Thermal RAIs on HI-STORM 100U

Topic 1: Inclusion of Wind in the Normal Long-term Storage Condition Evaluation (RAI 4-1 and 4-2)

Topic 1: Effect of Steady (Constant in Speed and Direction) Wind on Peak Cladding Temperature

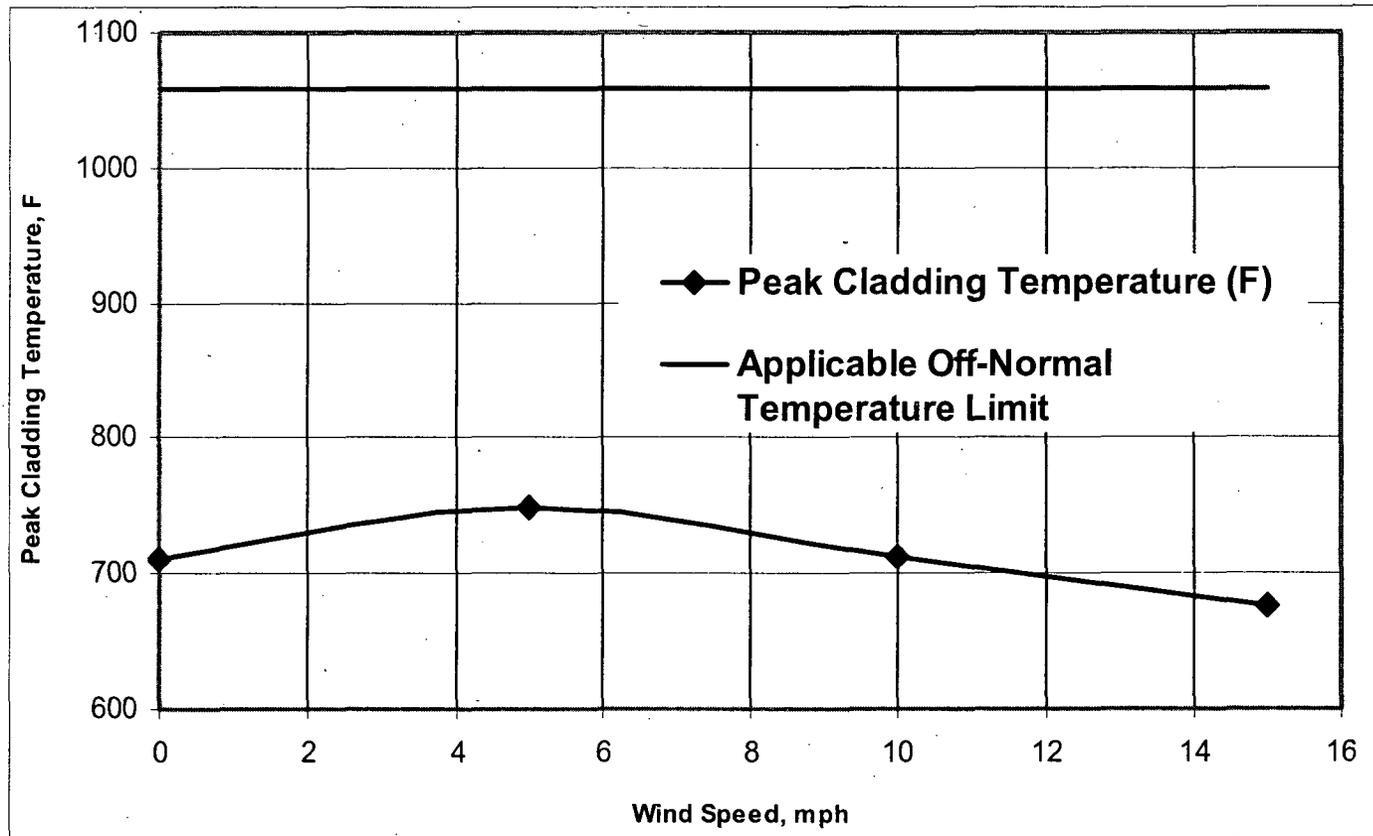
- Any dry storage cask system, and the spent fuel contained therein, is subject to changing ambient environment, e.g. day-to-night ambient temperature variation, seasonal ambient temperature variation etc.
- These changes result in changes to the cask internal pressure and resulting cladding stresses. Time-varying stress fields can be represented by a combination of a mean stress plus a cyclic stress. The mean stress is the principal determinant of cumulative creep.
- Interim Staff Guidance 11 (Appendix A in Revision 3) states:
“Creep is the dominant mechanism for cladding deformation under normal conditions of storage.”
- Therefore, time-varying phenomena such as wind are not required to be considered as part of the long-term storage evaluations.
